HISTORIC AND DESIGN REVIEW COMMISSION

Agenda Item No: 23

HDRC CASE NO: 2016-119
ADDRESS: 1921 FREDERICKSBURG RD
LEGAL DESCRIPTION: NCB 6692 BLK 1 LOT N W 108.2 FEET OF 1
ZONING: C2NA H
CITY COUNCIL DIST.: 7
DISTRICT: Monticello Park Historic District
APPLICANT: David Komet/1921 Deco Building LLC
OWNER: David Komet/1921 Deco Building LLC
TYPE OF WORK: New Construction
REQUEST:

San Antonio Historic and Design Review Commission
Conceptual Design Review
1921 Fredericksburg Road

no planters - submitted at
HDRC 4.6.16

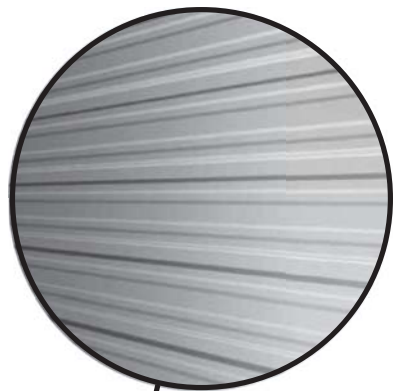
BF: no more planters?

SHEET:
A-1
SITE PLAN

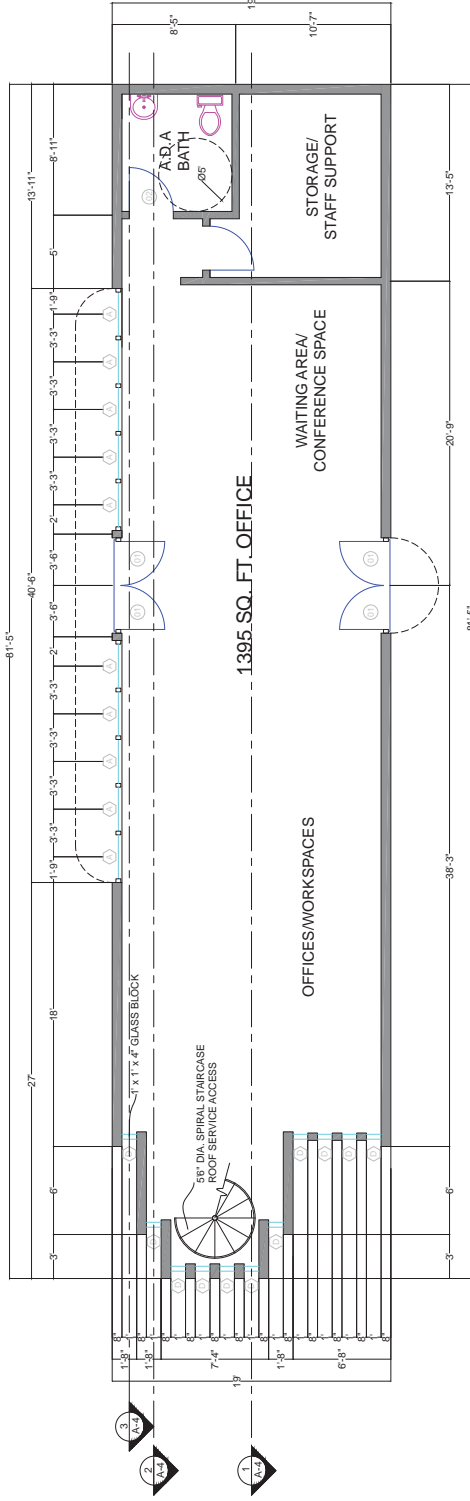
DL: in ground? What is the ground cover? 1

DL: Landscape on site plan is needed

BF: Site plan shows relation to neighbor well

SHEET:
A-3
 ELEVATIONS

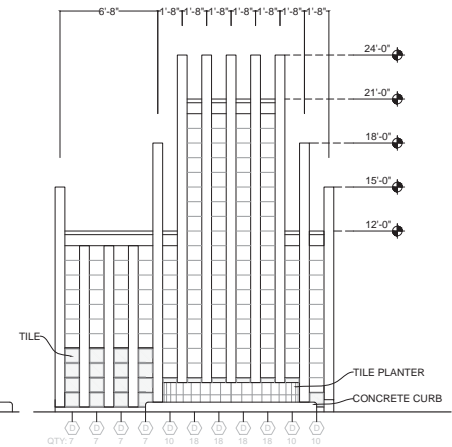
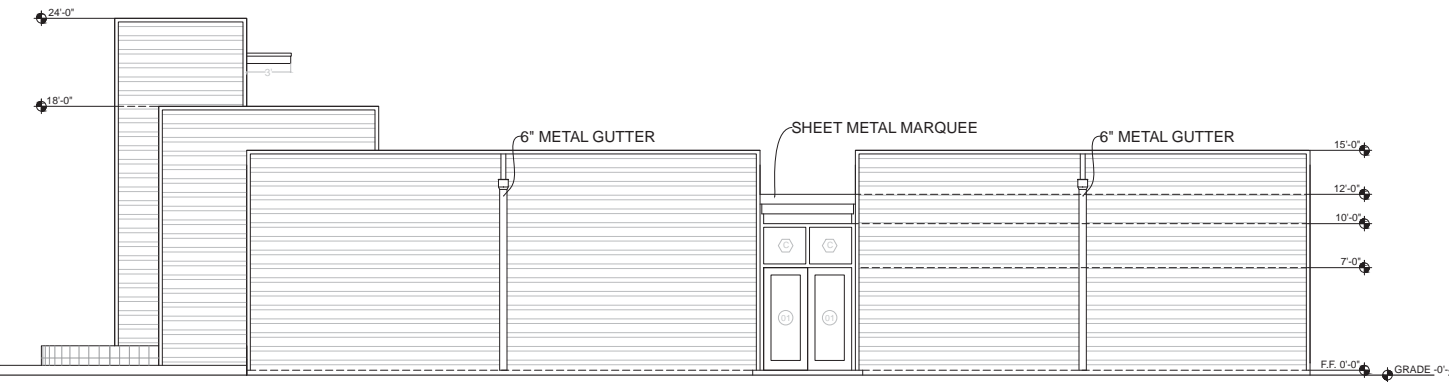
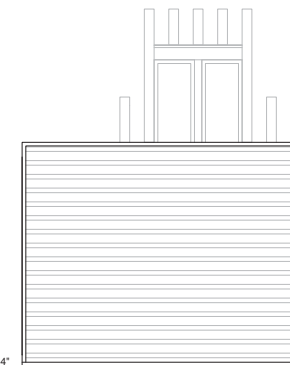
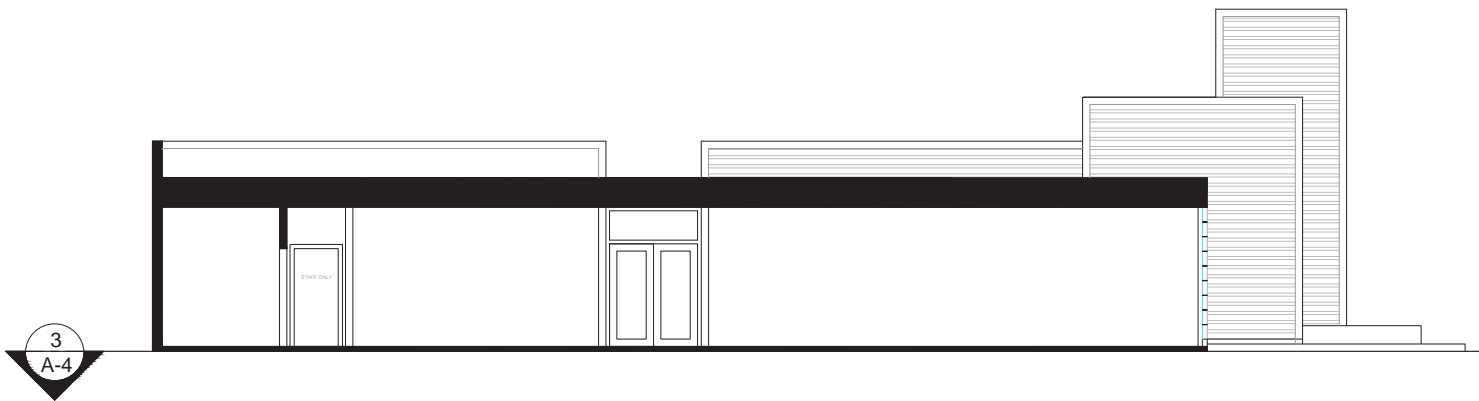
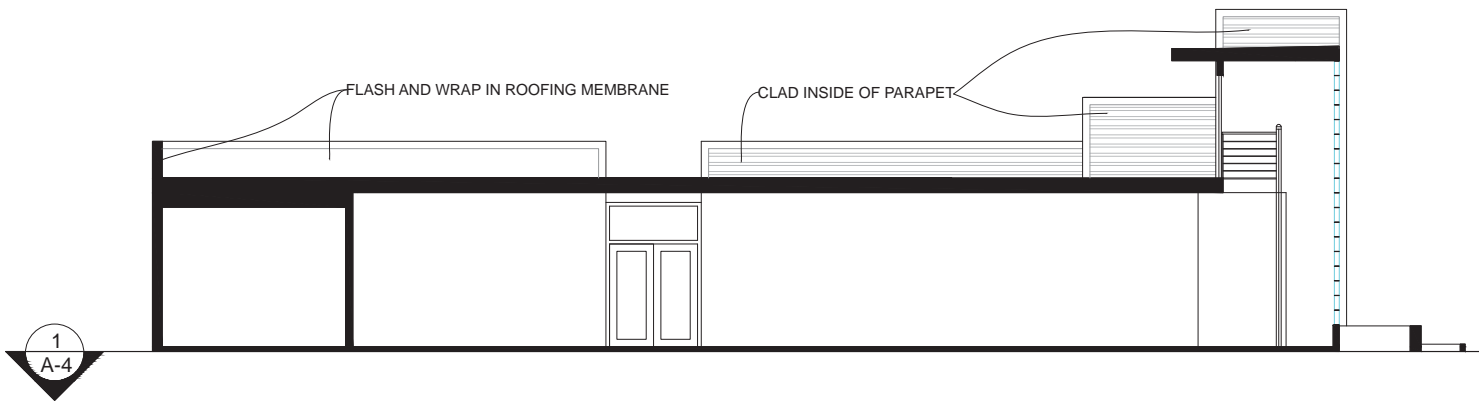
- j. The applicant is proposing that the new building have a floor to ceiling storefront along Fredericksburg Road, a glass rear double door, and ribbons of glass block between the wall planes on the corner façade. According to the Guidelines for New Construction 2.C.ii., blank walls should be avoided on elevations that face the street and new construction should feature window and door openings with a similar proportion of wall to window space as found in historic facades. The proposed façade configuration is not consistent with the Guidelines.

DL: siding material? Dimensions? see seems every 3'?

DL: Are there vertical seams? NO. Gutters hide only vertical seam

DL: What is prow overhang?

DL: Lighting on front facade?
